Planning Commission Regular Meeting

Planning Commission Staff Report

Subject:	Stouffer Residence Landmarking, Restoration, and Addition (Class A Major Development Permit, Final Hearing; PL-2025-0355)		
Proposal:	A proposal to locally landmark and rehabilitate an existing historic primary residence, demolition of the non-historic saltbox addition, and a new addition in the rear of the lot. The project proposes 3,668 sq. ft. of total density which includes four (4) bedrooms, five (5) bathrooms, an office, and a two-car garage (500 sq. ft.). The historic barn will also be fully rehabilitated and turn into a shop space. The project includes (1) one gas fireplace and 475 sq. ft. of heated paving and walkways.		
Date:	March 13, 2026 (For meeting of March 17, 2026)		
Project Manager:	Clif Cross, Planner II		
Applicant/Owner:	Merrick and Lauren Crispell		
Agent:	J.L. Sutterley, Architect		
Address:	110 South Harris Street		
Legal Description:	Lot 6, Block 7, Yingling & Mickles Addition Subdivision

(1) cottonwood
2" caliper

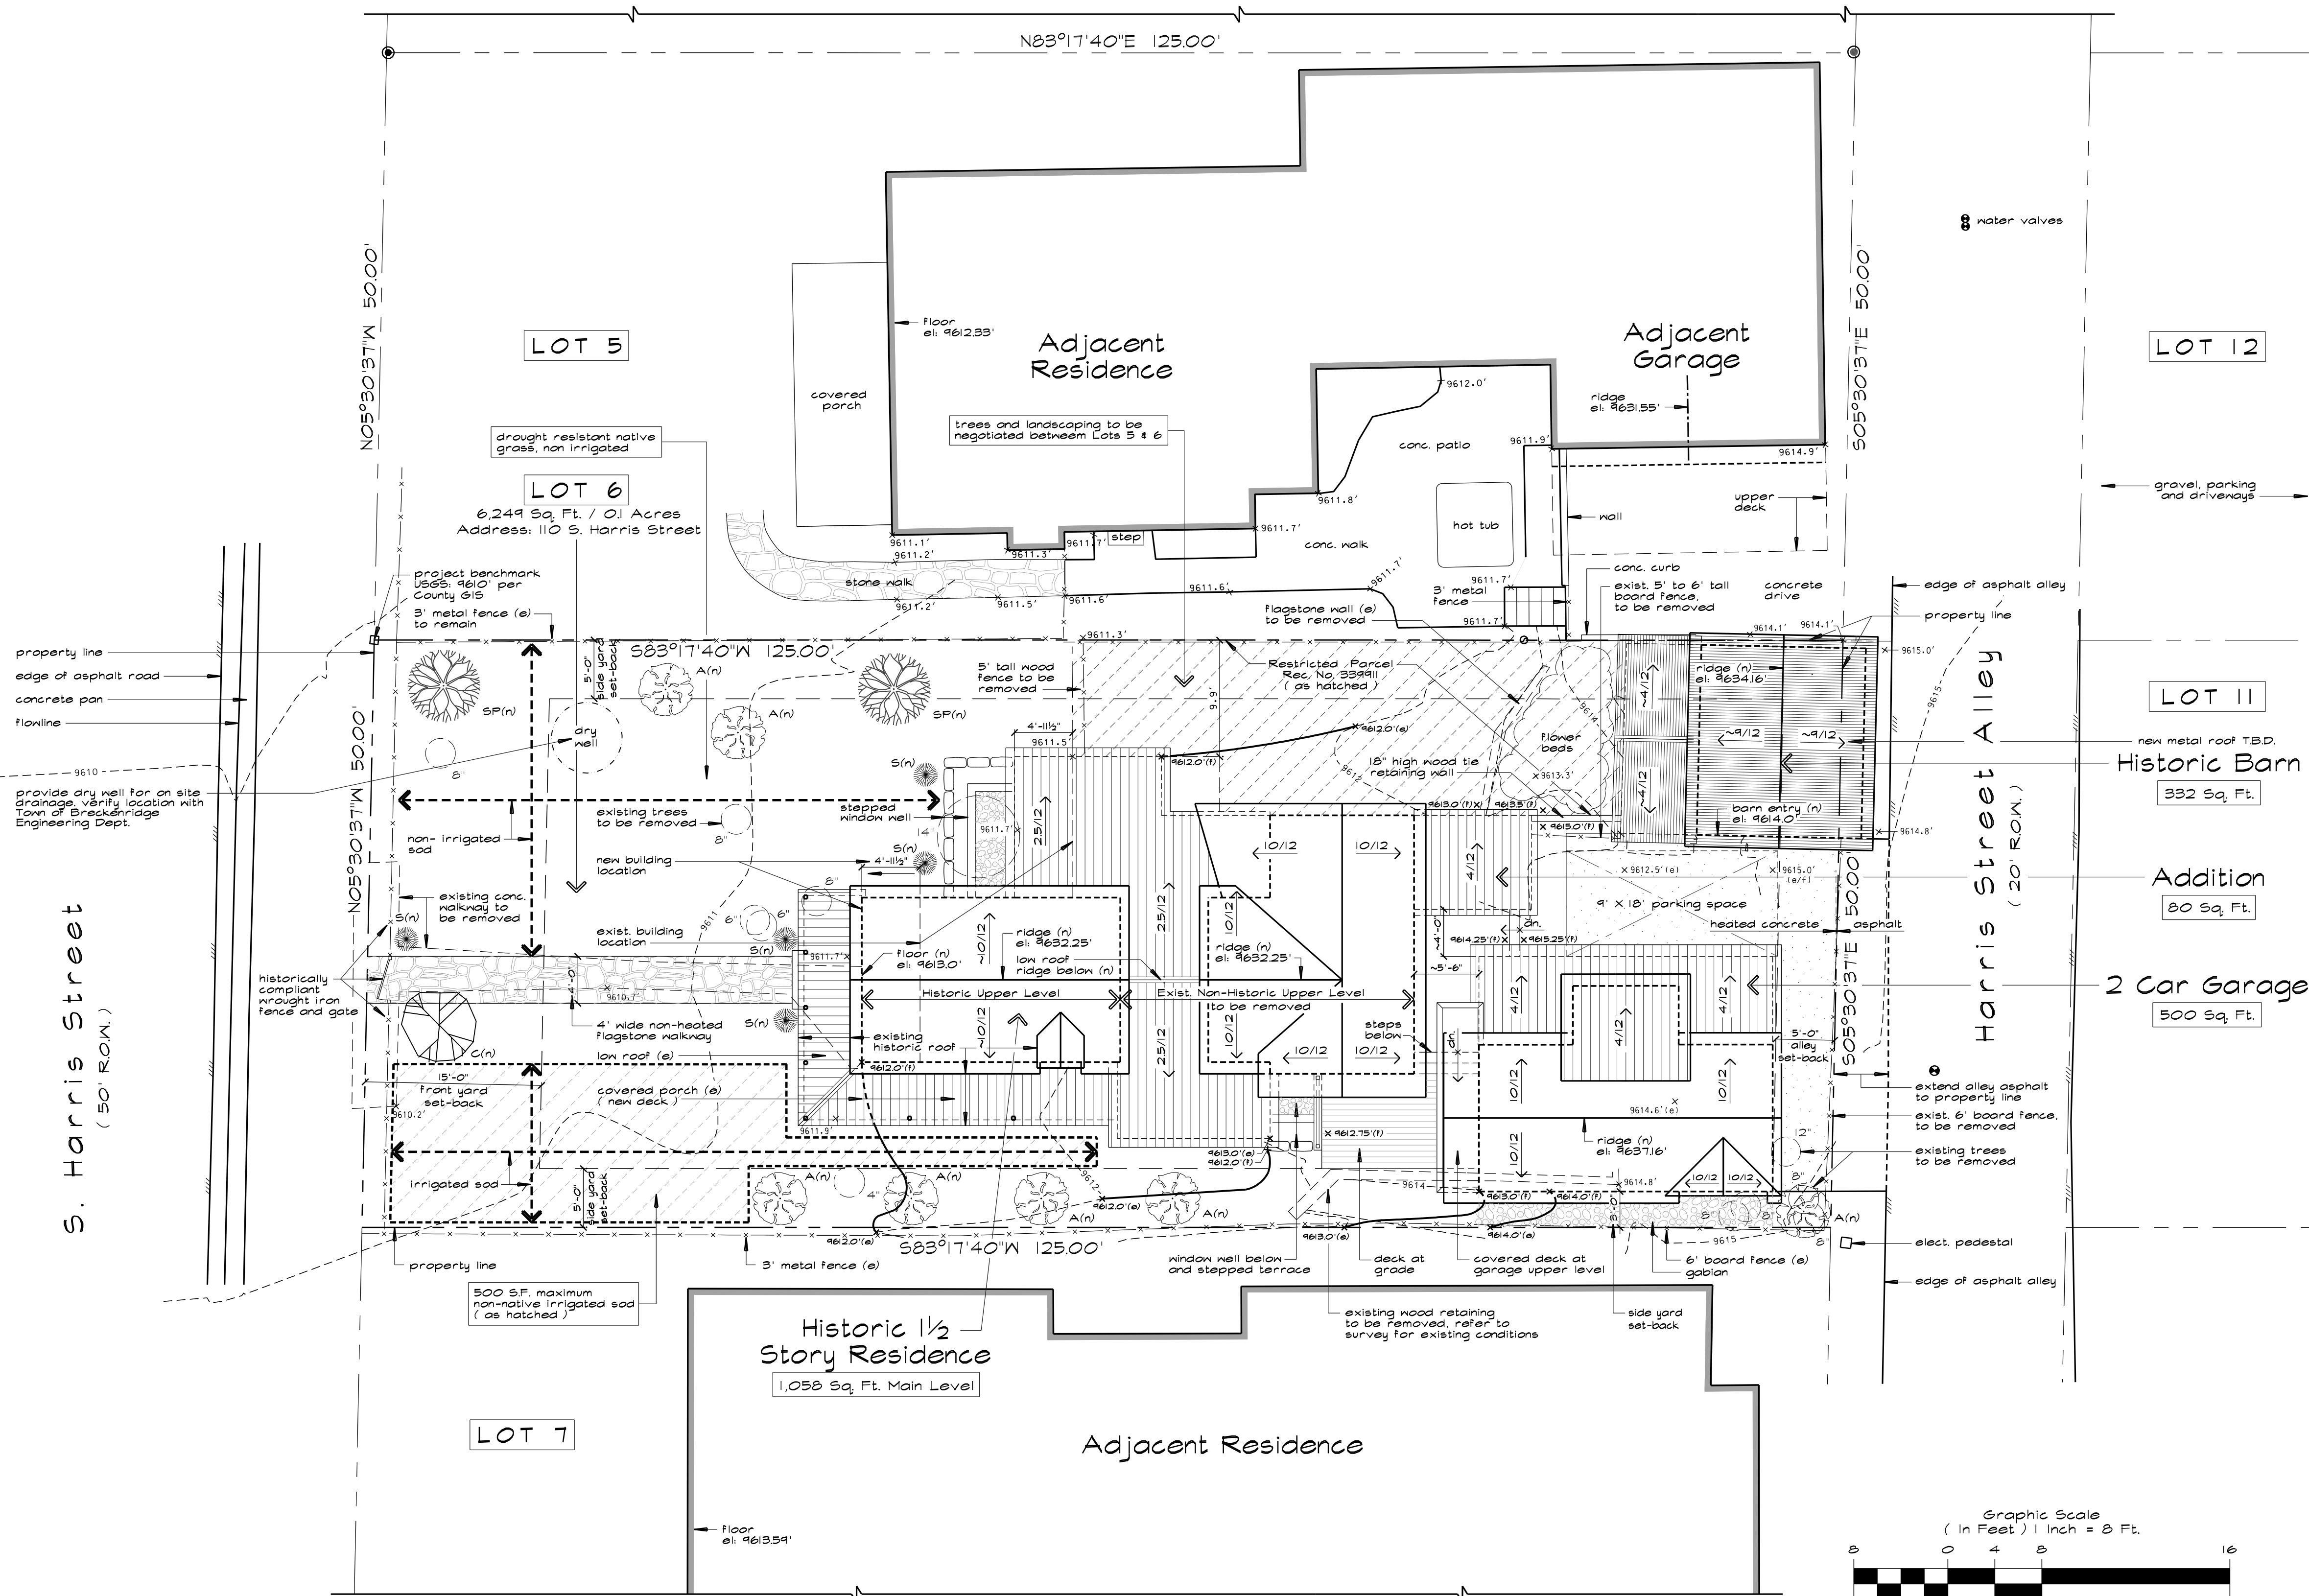
3. Additional details were added to clarify the proposed landscaping. The applicant added one (1) cottonwood planting to satisfy the Handbook of Design Standards. Staff have removed the recommended assignment of negative three (-3) points.

Plant Material & Landscaping (22/A & 22/R): Since the preliminary hearing, the applicant has proposed one (1) Cottonwood (2" caliper), in addition to the previously proposed two (2) native Engelmann Spruce ranging from 6 to 8 feet in height, seven (7) Aspen trees at 2-inch caliper (50% multi-stem), and mix of five (5) shrubs.

Staff notes the applicant has not provided the specific sod type for either of the proposed non-irrigated or non-native. Staff have added a Condition of Approval requiring the applicant to provide the details at the time of Building Permit submittal on the two (2) proposed sod types to ensure the non-irrigated sod is a native seed mixture to comply with Policy 22/R.

As mentioned above, the applicant has added one (1) Cottonwood to the landscape plan to comply with Design Standard 102 and 132, which requires Cottonwood plantings along the street edge. Staff has removed the negative three (-3) points from the analysis and finds the landscape plan provides appropriate screening and complies with the applicable policies and standards of the Handbook of Design Standards.

North Elevation

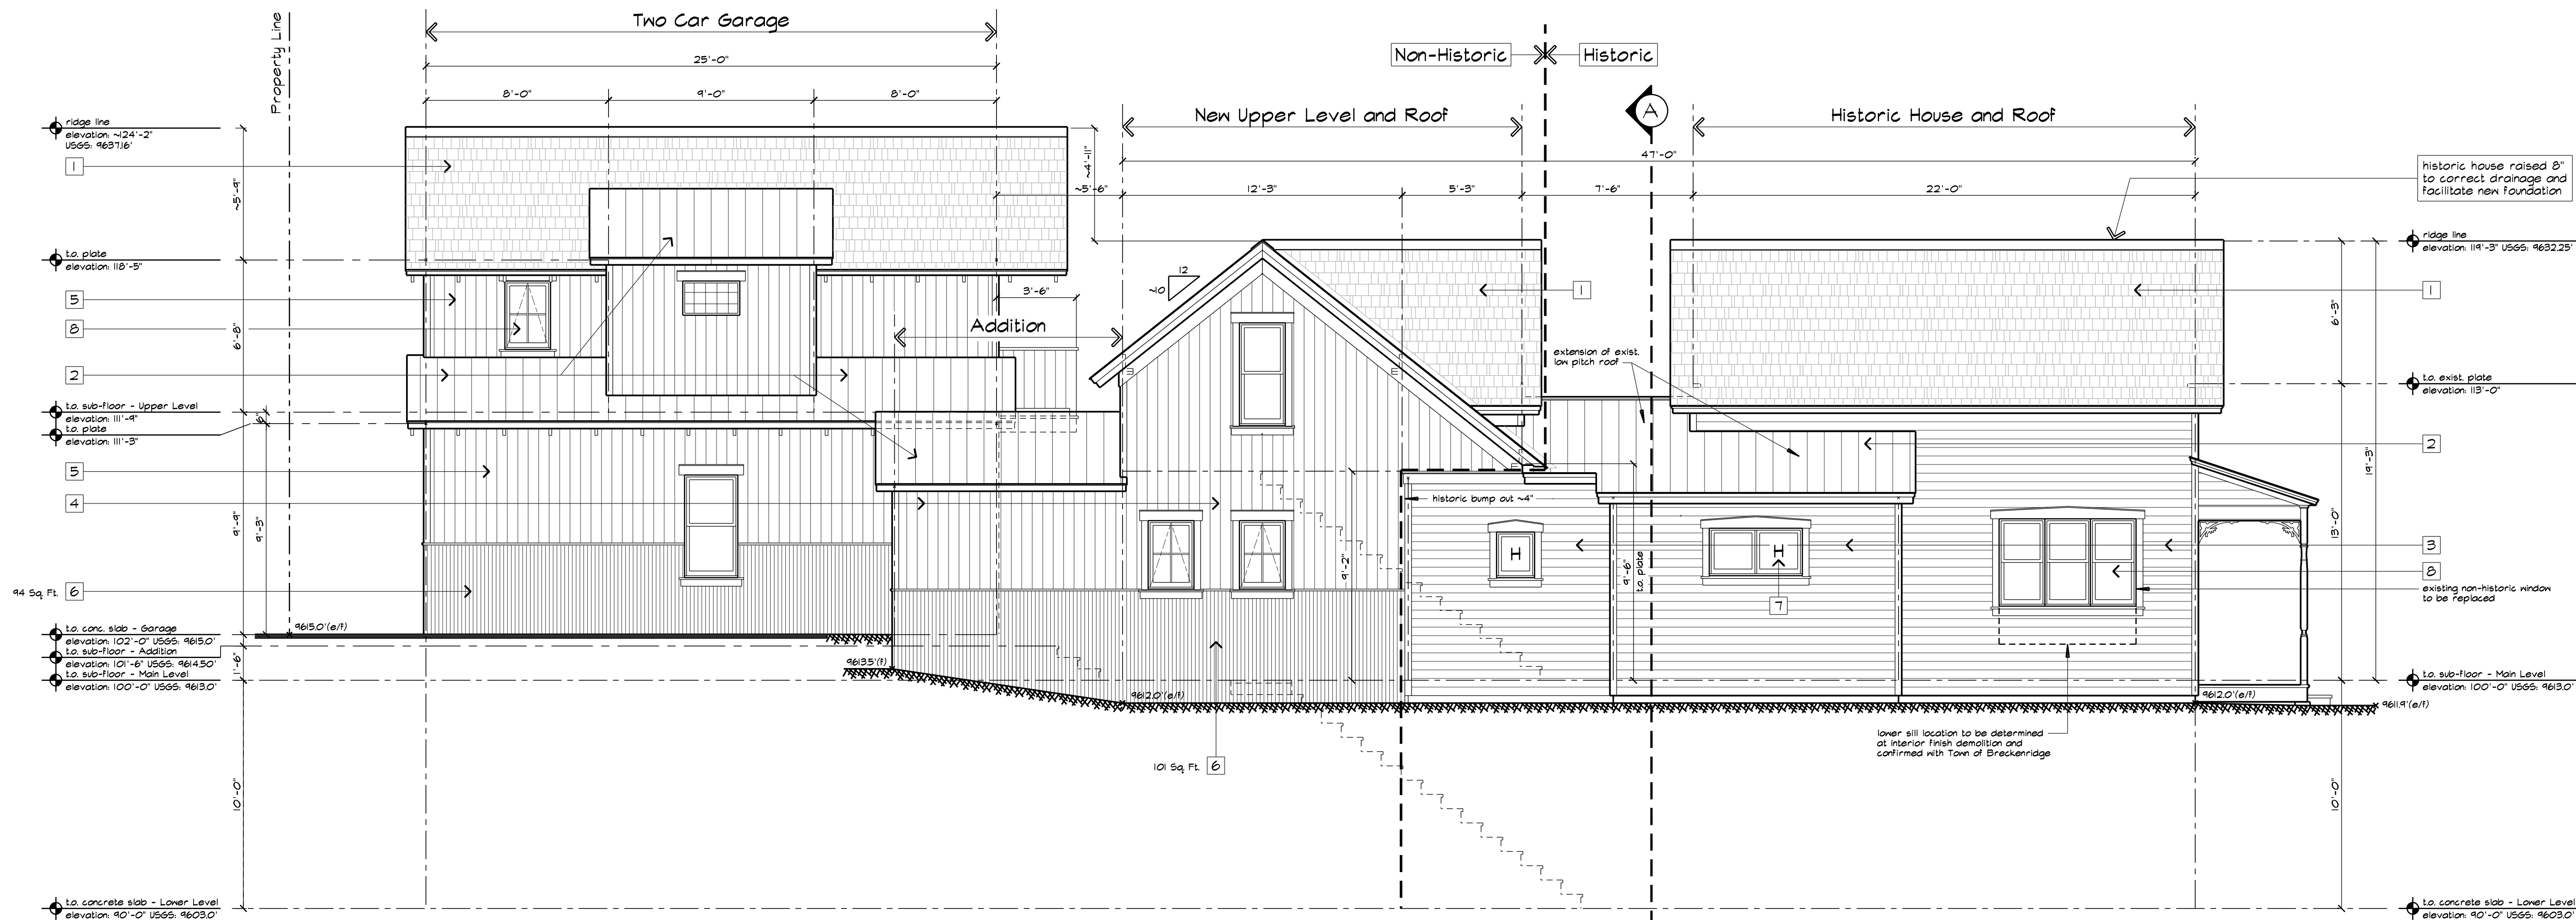
The applicant has identified additional investigation is necessary for the determination of the historic materials for the proposed window replacement on the northern elevation of the living room. Staff have added a Condition of Approval requiring the applicant to submit proof of the historic window framing prior to the removal of any historical fabric for the proposed window.

- 12. Applicant shall contact the Town of Breckenridge to provide information regarding the historic window on the northern elevation of the living room after additional discovery has taken place to identify the lower sill location. If the proposed window impacts historic fabric, the project shall return to the Planning Commission for negative points or provide an alternative window design that does not impact historic fabric.**
